Application Ref: NP/20/0407/FUL

Case Officer	Andrew Richards		
Applicant	Mr A Evans		
Agent	Mr R Hyde, Design by Hyde		
Proposal	Demolition of existing garage/workshop, and other extensions. Modernisation of existing building and new two storey extension to form a change in use to provide Key worker accommodation (C3 class) which comprises, 18 No. self-contained studio rooms. The proposal provides 9 No. parking spaces at the front and rear of the property with one being a disabled space. There is also provision for six cycle stands at the rear.		
Site Location	Coed-derw, St. Brides Hill, Saundersfoot, Pembrokeshire, SA69 9NP		
Grid Ref			
Date Valid	24-Aug-2020	Target Date	18-Oct-2020

Pembrokeshire Coast National Park Authority
Development Management Committee – 10th March 2021

DRAWING NO. 1801-PL-07 / SCALE: 1:100 @ A2 / 07.11.19 / REV: C

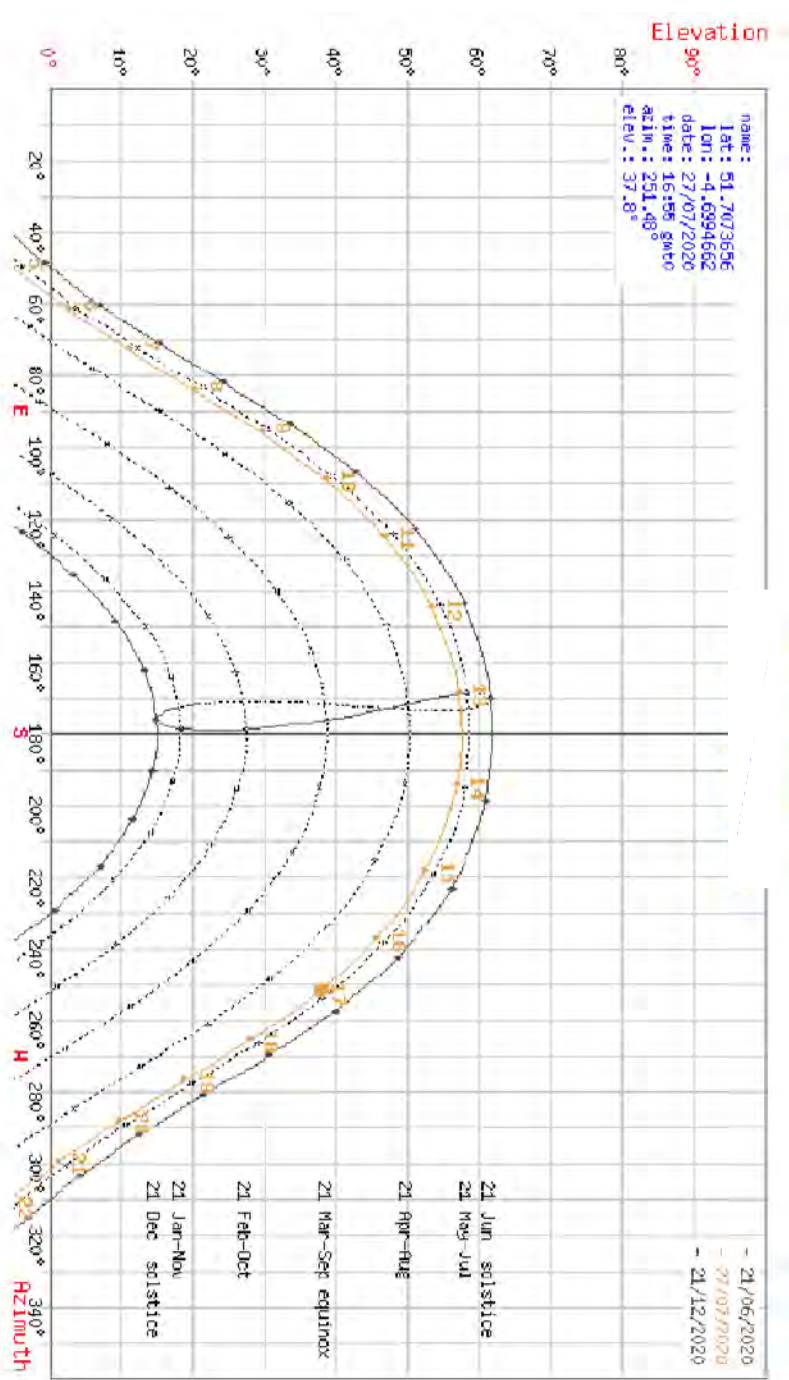
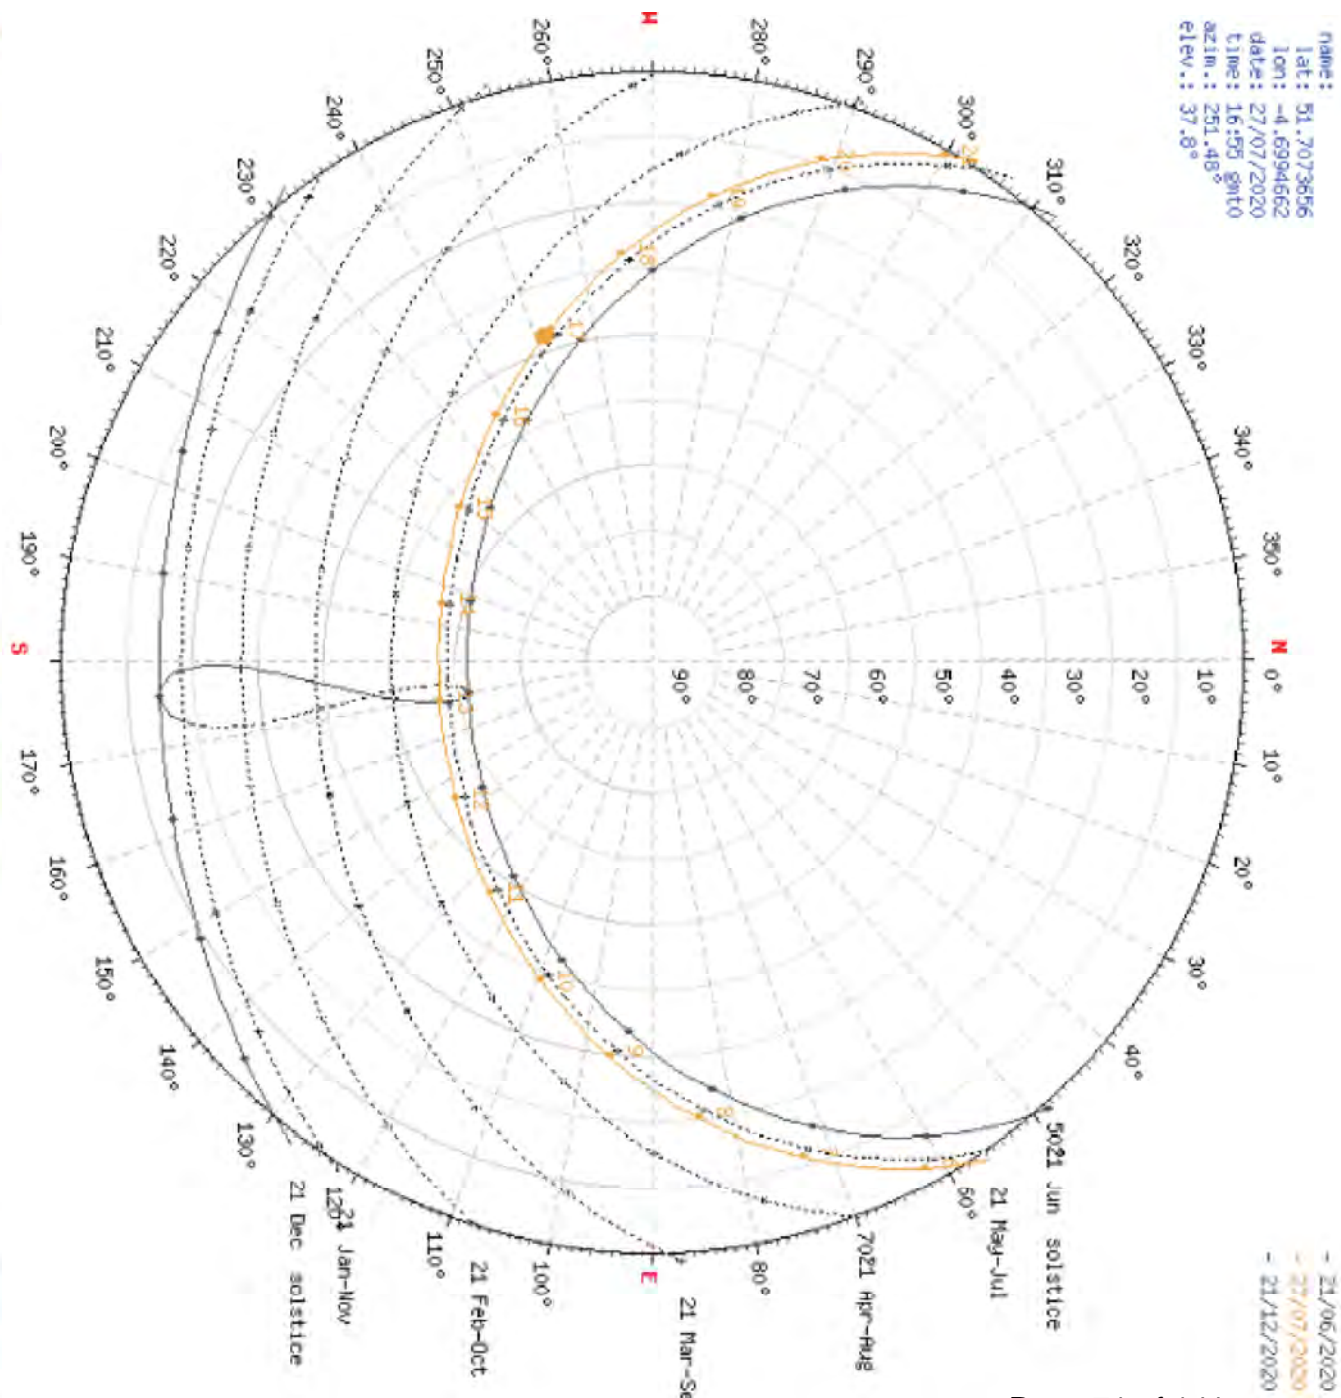
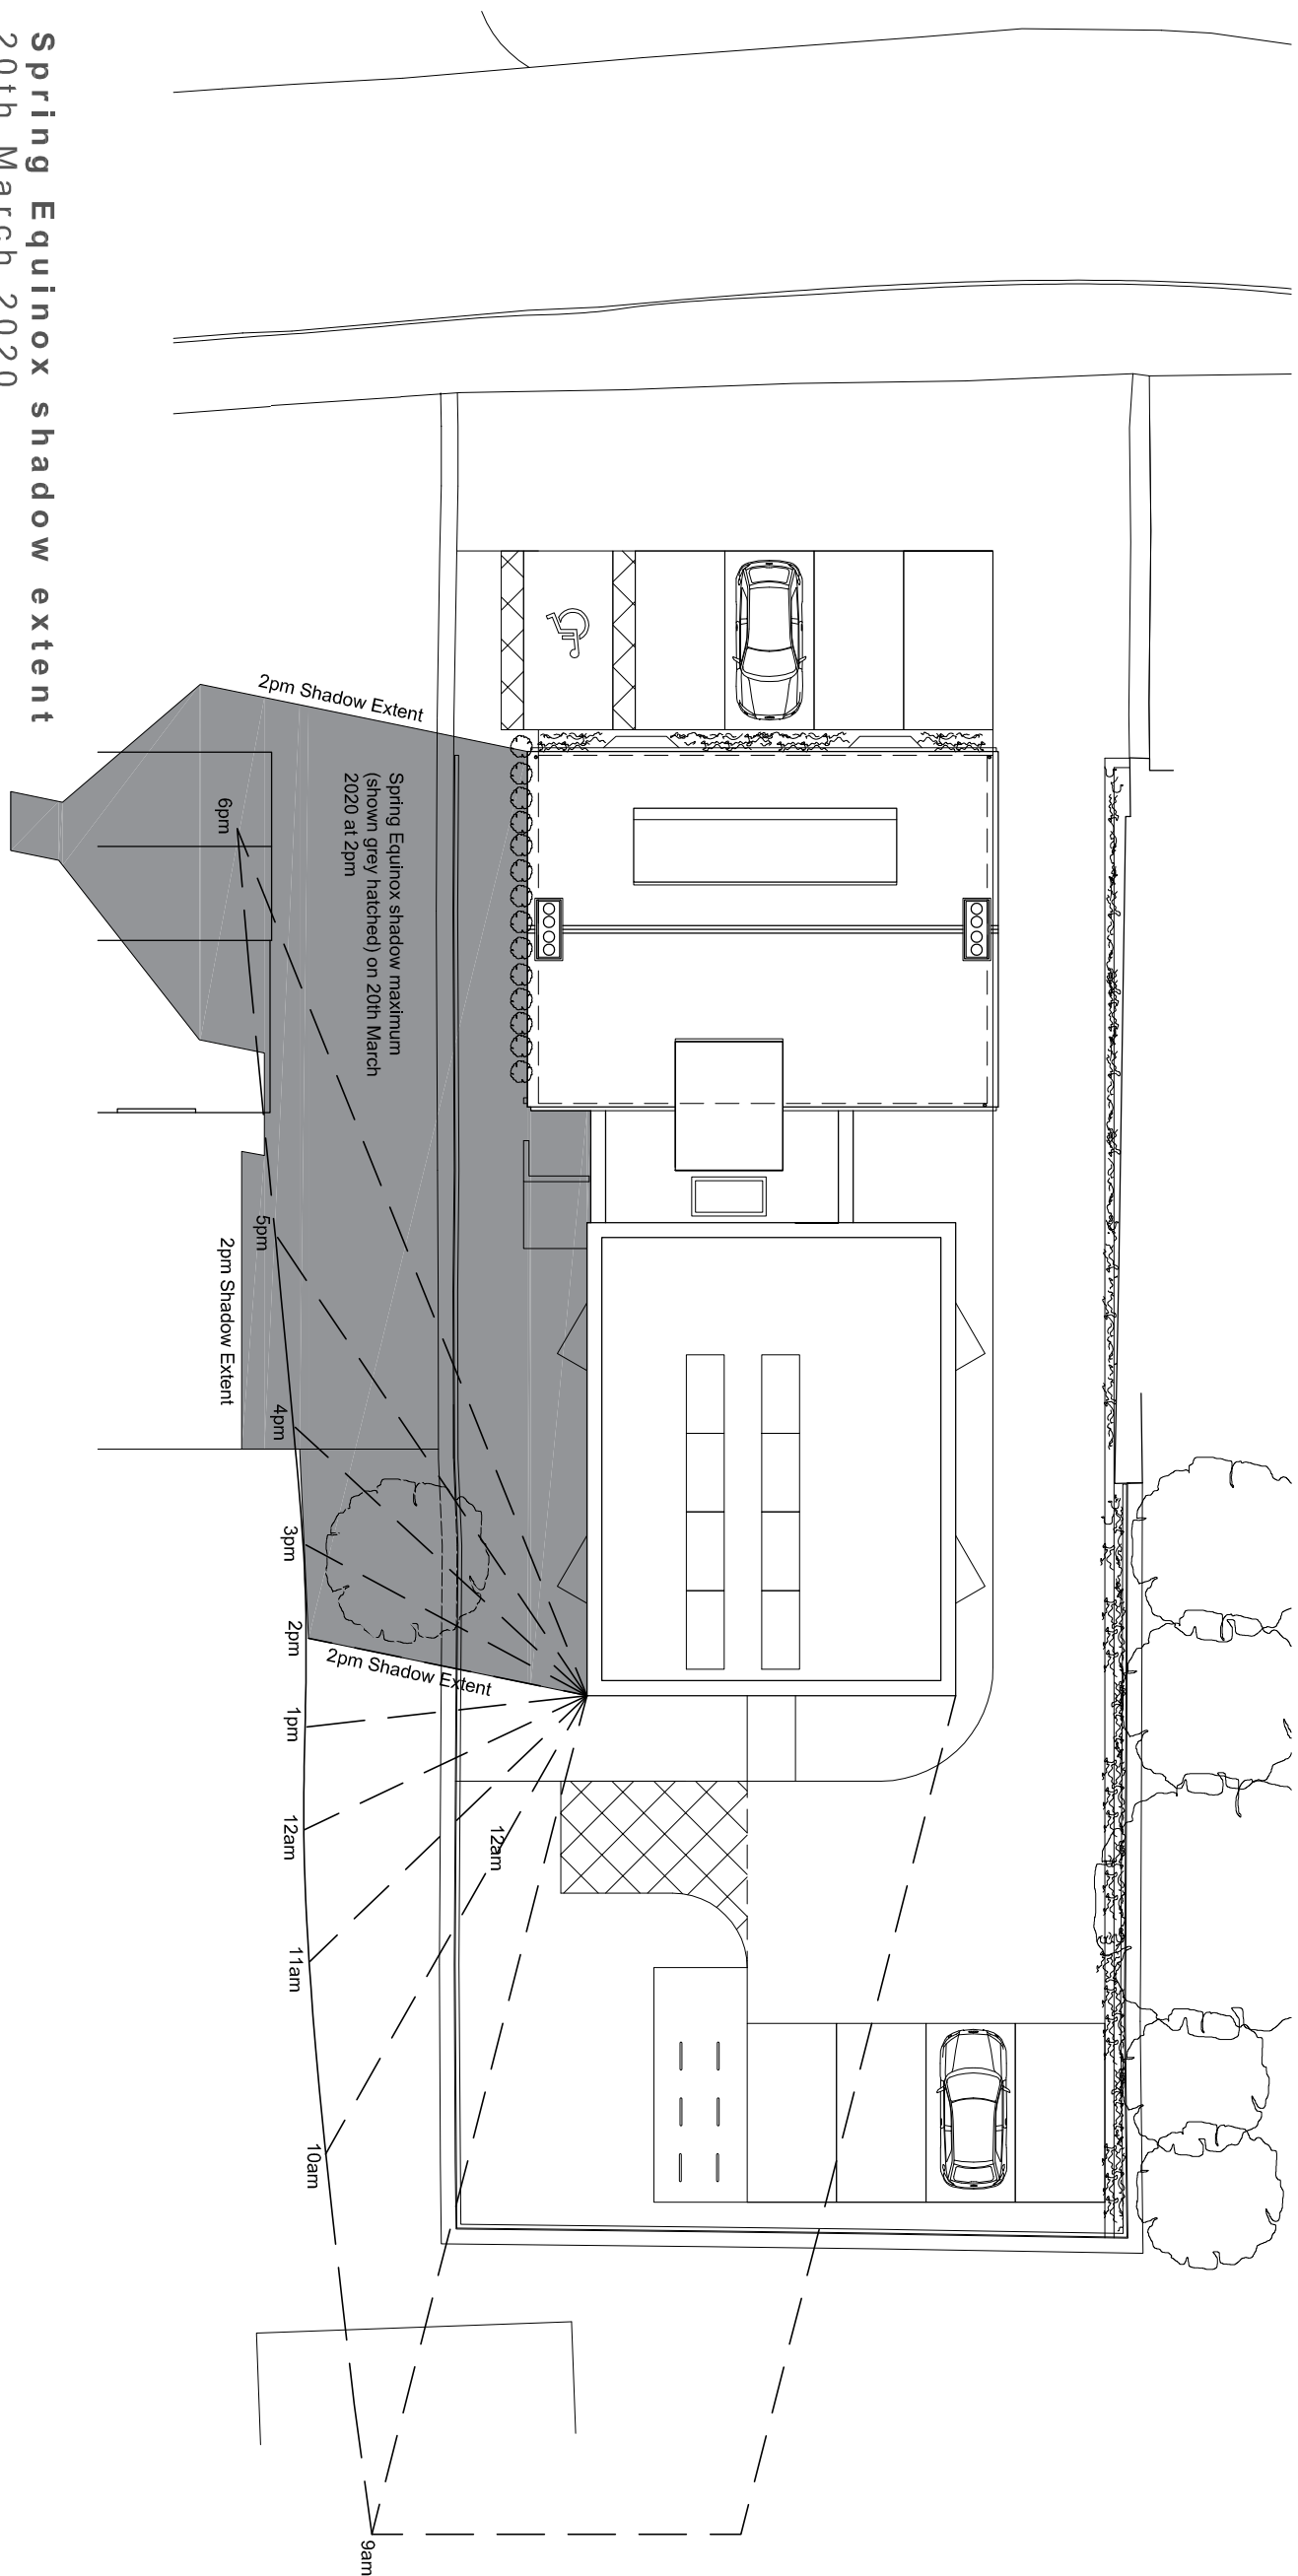
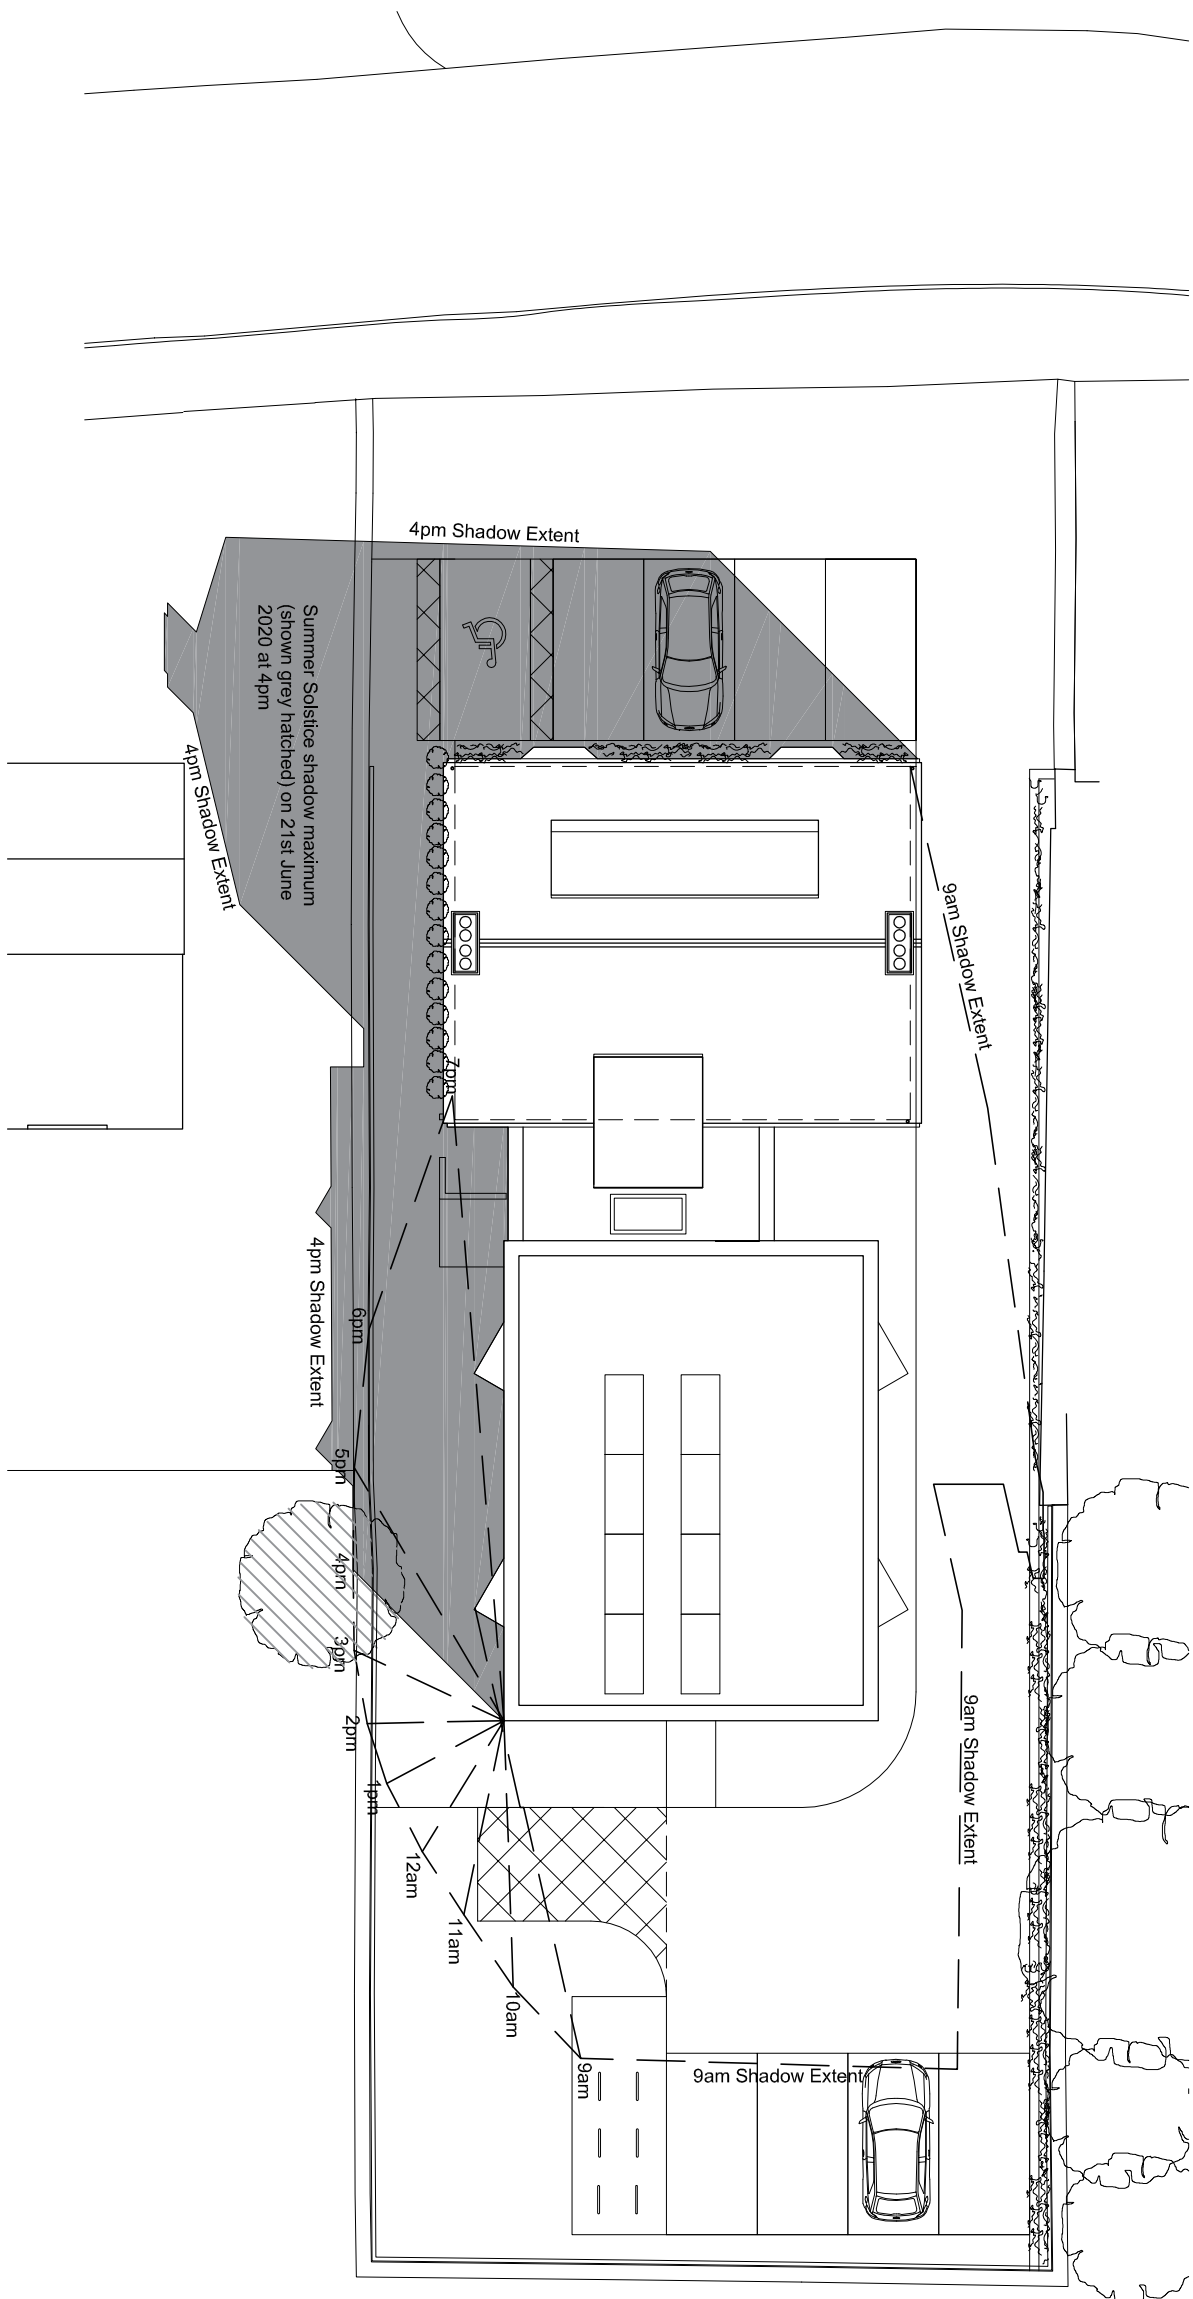
Whilst the extension is set in off the northern boundary by some 3.5 metres and the neighbouring dwelling is also set off the same boundary by 5 metres, the mass of the new extension would have an overshadowing impact from the south west on one of the neighbouring dwelling as annotated by the agent on the submitted drawing references 1801-PL-08-RevB. It is noted that this overshadowing impact is small and at a distance of approximately 17 metres which should result in no detrimental impact from overshadowing on the neighbours to the side habitable rooms.

REV: C JAN 21 North East elevation extent added
